**Comment Response Matrix  
for  
Nuclear Regulatory Commission RAI-2009-02  
Second Request for Additional Information (RAI) on the  
Saltstone Disposal Facility Performance Assessment  
(SRR-CWDA-2009-00017, Revision 0, dated October 29, 2009)**

**April 2011**

Prepared by: Savannah River Remediation LLC  
Closure & Waste Disposal Authority  
Aiken, SC 29808

Figure 1: Tc-99 release over the 10,000-year compliance period based on results (a) WSRC-STI-2007-00056 and (b) the 2009 PA model results

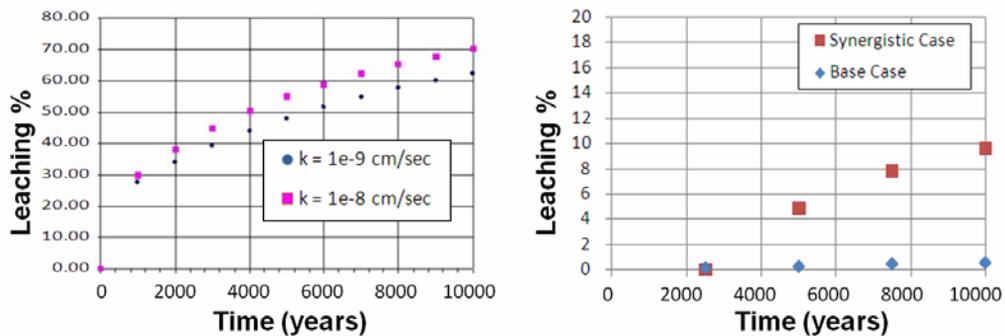
As discussed in WSRC-STI-2007-00056, experiments on Tc-99 leaching from saltstone simulated grout were conducted and the results incorporated into PORFLOW modeling. Figure 1 shows the modeled release of Tc-99 according to WSRC-STI-2007-00056 and the 2009 Saltstone PA. The modeled Tc-99 release for WSRC-STI-2007-00056 is approximately 60% over the 10,000-year compliance period for saltstone with a hydraulic conductivity of 1E-9 cm/s, which is slightly less than the assumed hydraulic conductivity in the 2009 PA of 2E-9 cm/s. According to the PORFLOW model files in the 2009 PA, the predicted release of Tc-99 from the saltstone material is 0.6% for the base case and 9.6% for the synergistic case.

The research presented in WSRC-STI-2007-00056 demonstrated the release of Tc-99 due to the presence of residual oxygen for an intact saltstone monolith. Residual oxygen would be consistent with field conditions at the SDF as would the transport of gas and liquid-phase oxygen to the fractured vaults and saltstone. In addition, the saltstone grout has been shown to be fractured which would increase the surface area-to-volume ratio, thereby increasing the oxidation of saltstone.

NRC staff recognizes that research is ongoing and that the results presented in Figure 1 below are based on a modeled system. However, this model is parameterized from experimental results conducted with a saltstone simulant whereas the shrinking core model utilized in the PA is less empirical. Additionally, some key parameters of the shrinking core model, such as the Tc  $K_d$  are based on a formulation that is drastically different than saltstone (see SP-15).

<p><b><u>Path Forward</u></b></p> <p>The PA should be consistent with relevant research or justification should be provided discussing why it was excluded. Provide any additional references on Tc-99 leaching from saltstone that have not already been provided to the NRC.</p>
<p><b><u>RESPONSE SP-19:</u></b></p> <p>Response will be provided in SRR-CWDA-2011-00044, Revision 1.</p>
